STORM SEWER IMPROVEMENTS to serve **VERANDAS AT CRESTVIEW APARTMENTS** 300 NORTH 127TH STREET EAST CITY OF WICHITA, KANSAS, 67206

Project Number
 2021-000671PPD (ORG CODE 56030970)

PPD PLAN

CU711

CU714

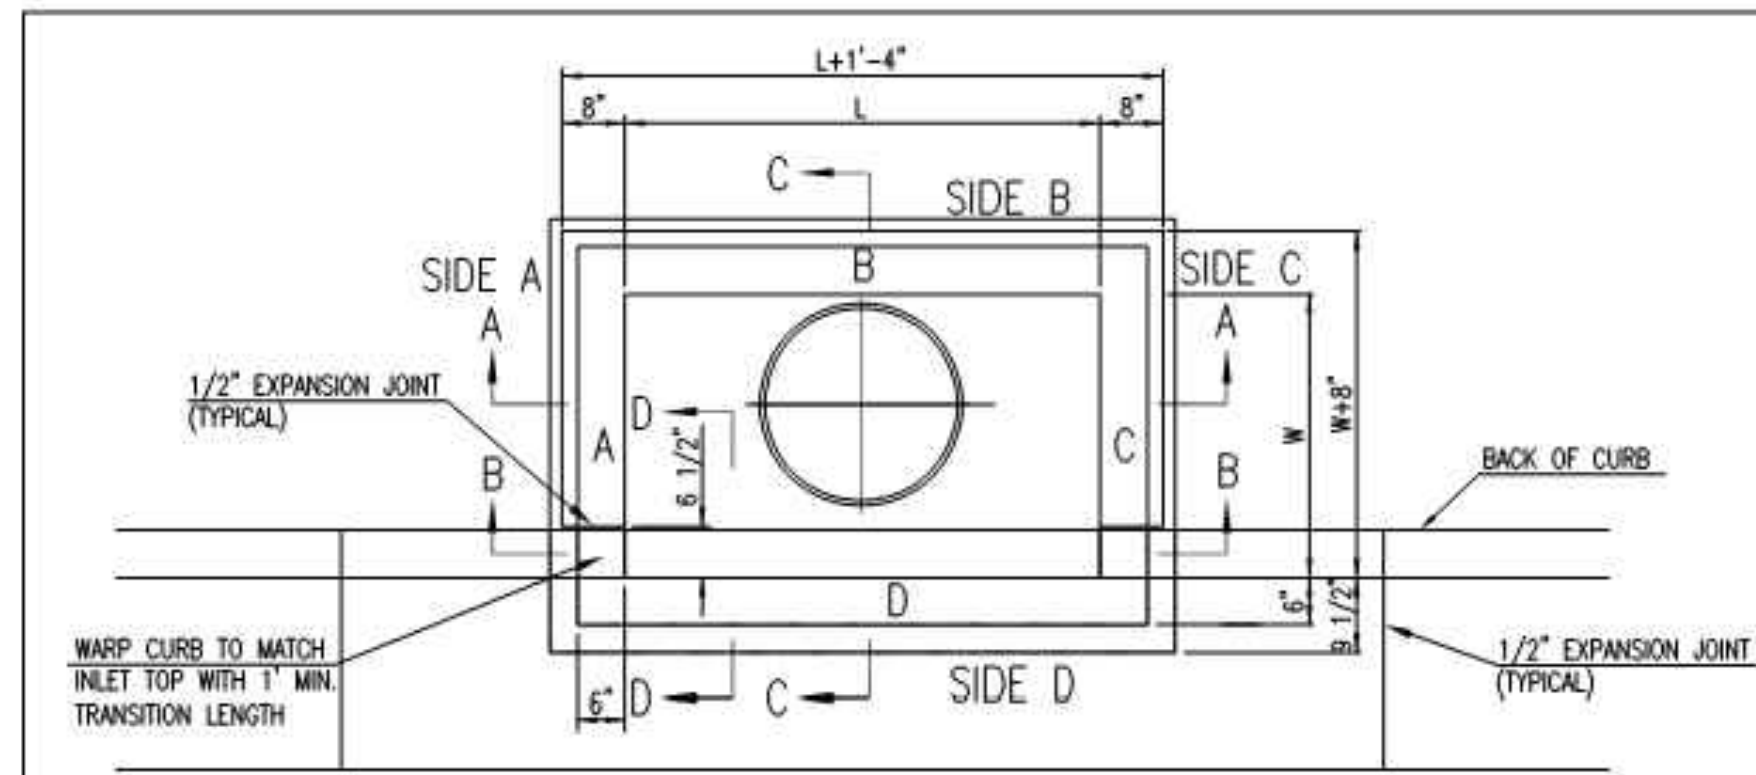
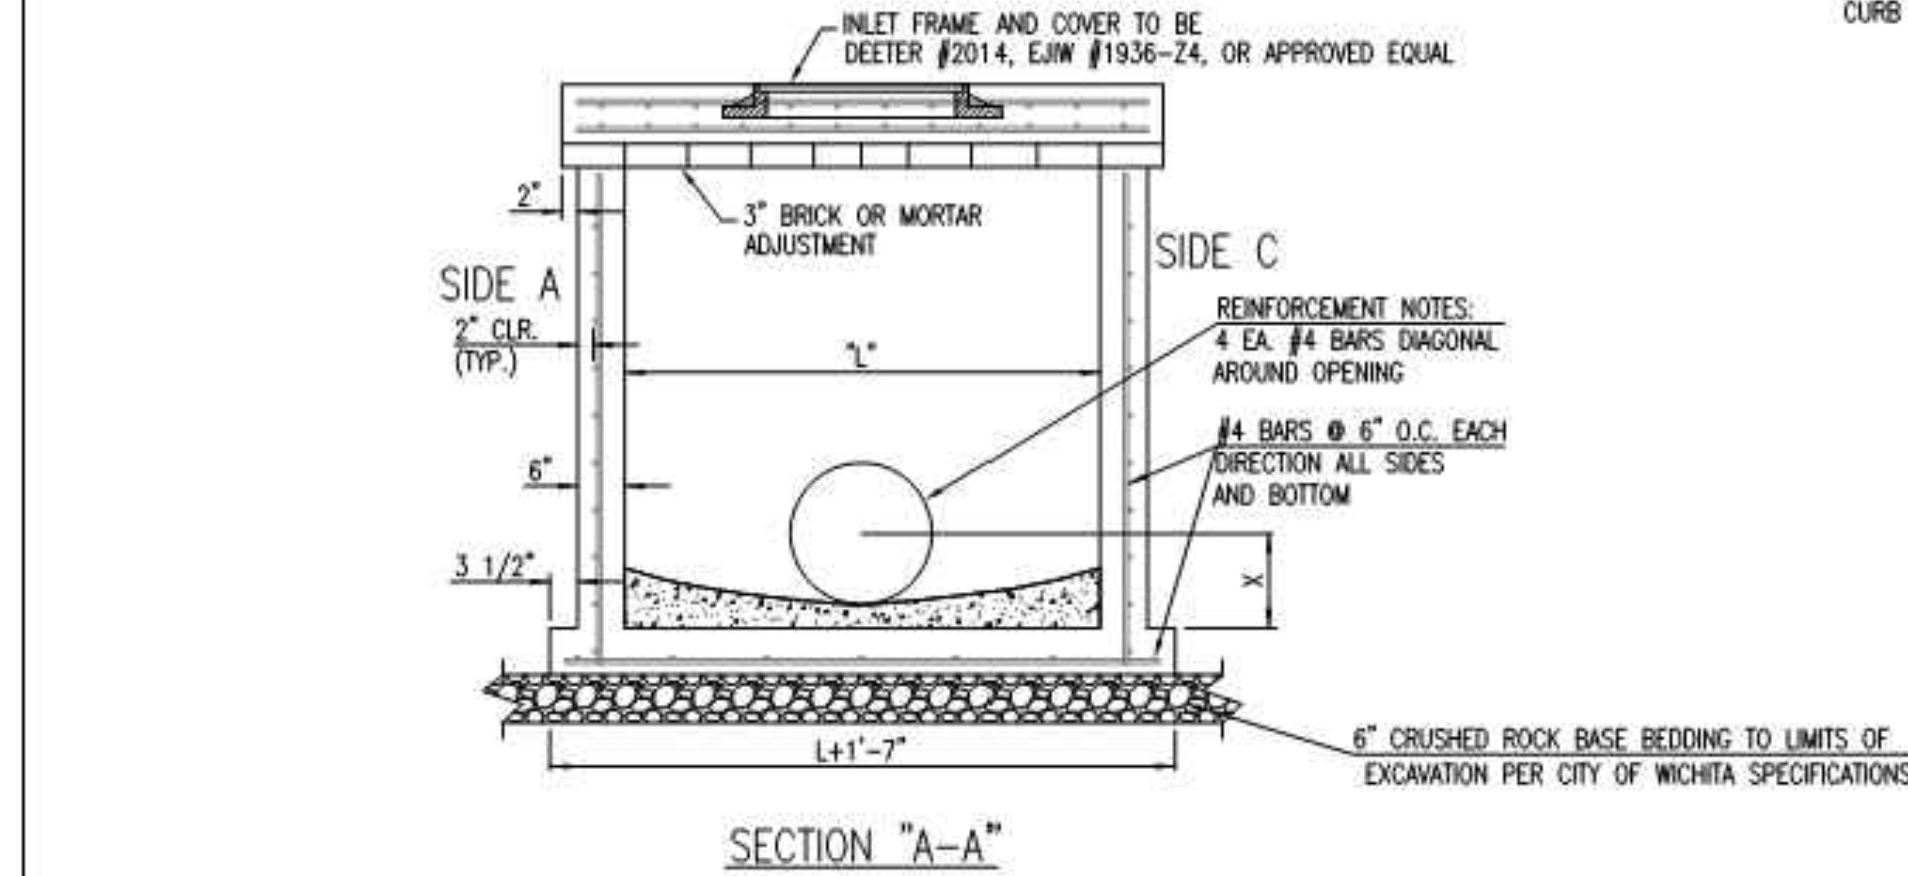
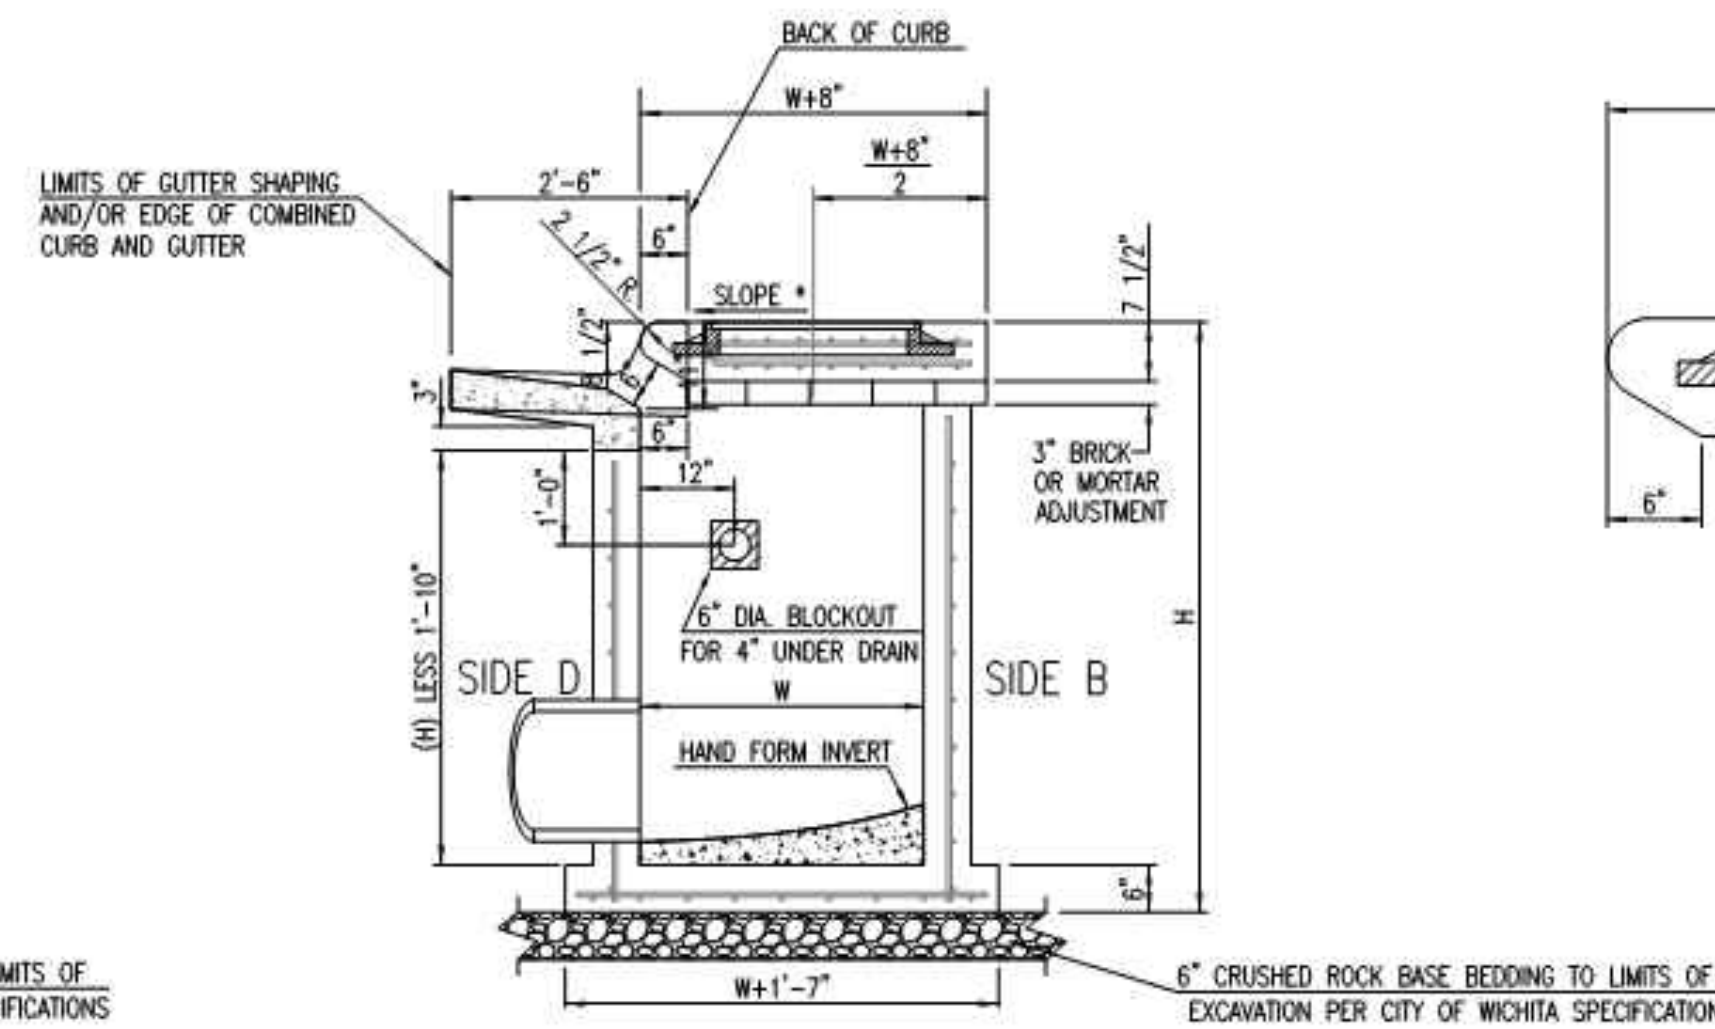
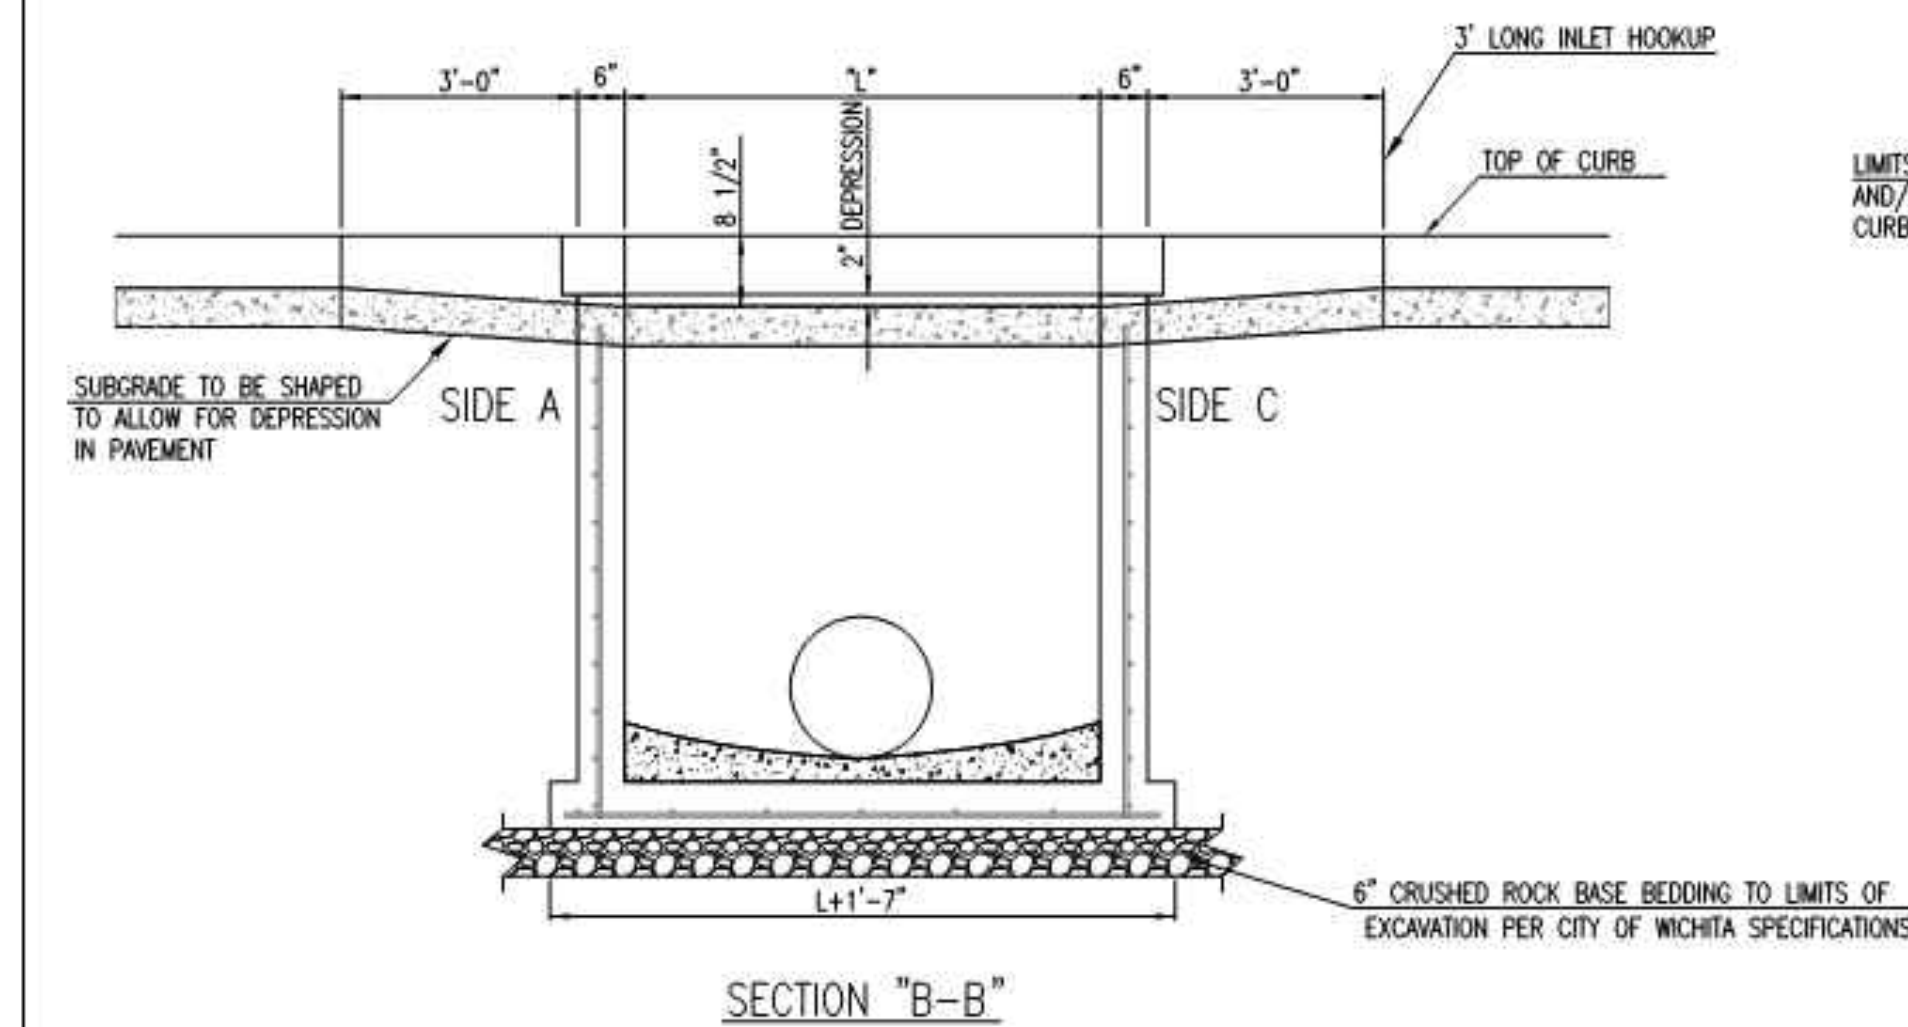
SW-301 MOVED TO DRAWING CU715.
 DETAIL 3 MOVED TO DRAWING CU716.

EROSION DETAILS
CE501

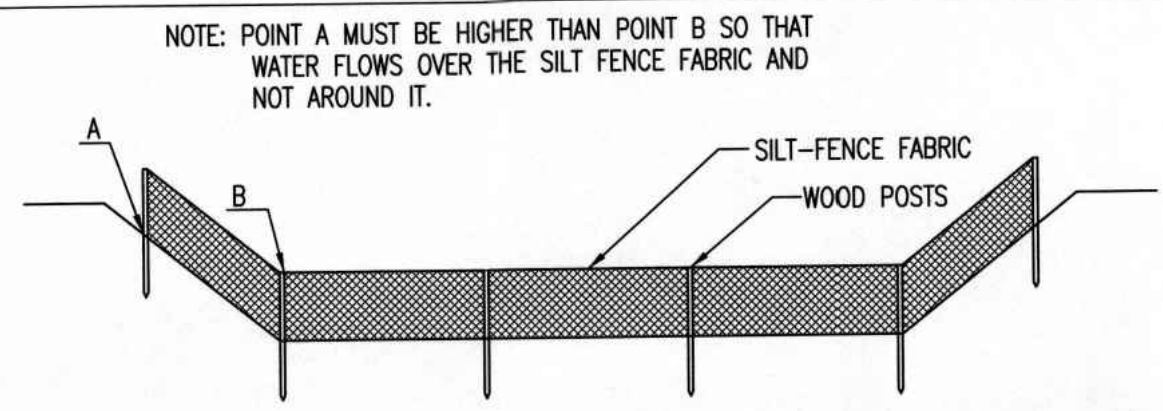
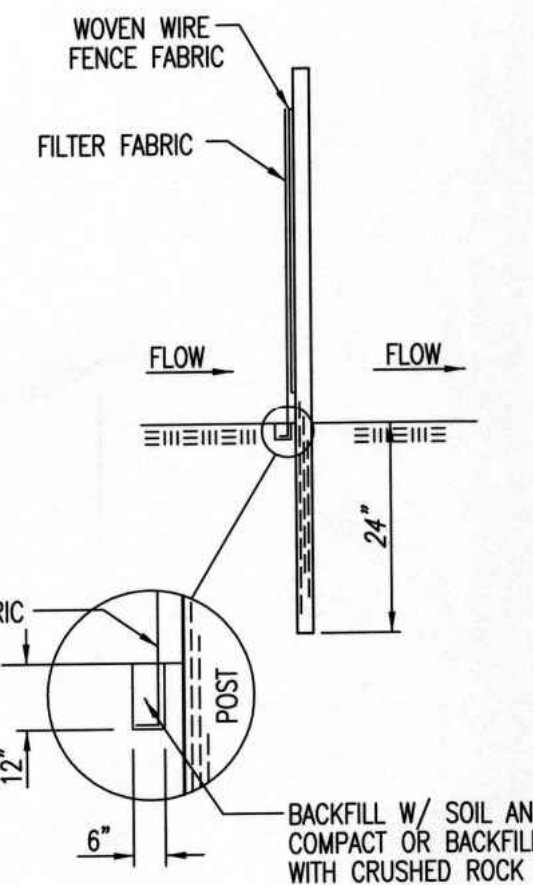
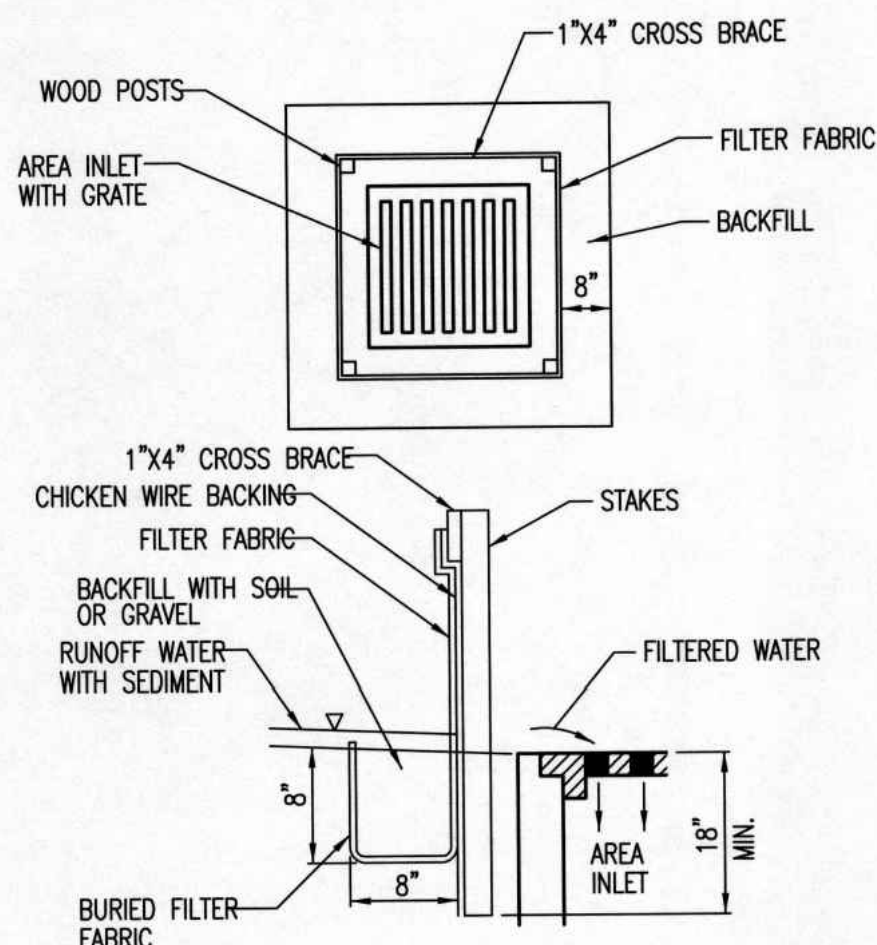
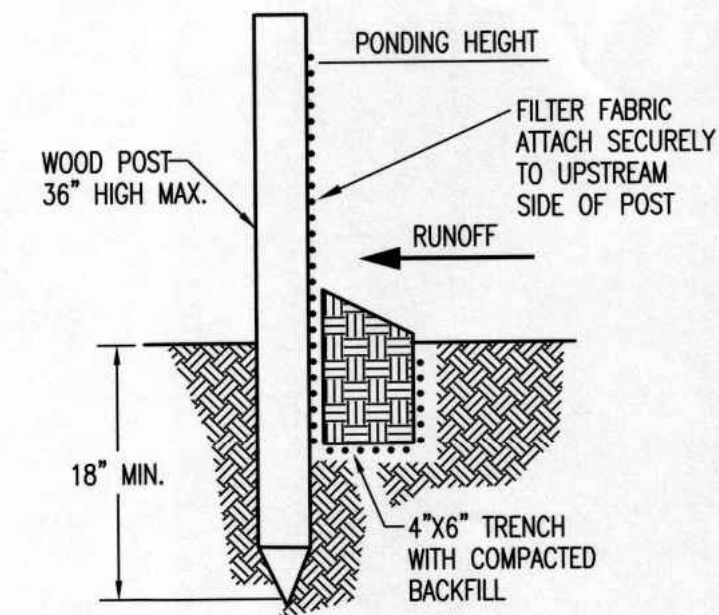
SW-502 MOVED TO DRAWING CE502.
 DETAIL 3 MOVED TO DRAWING CE503.
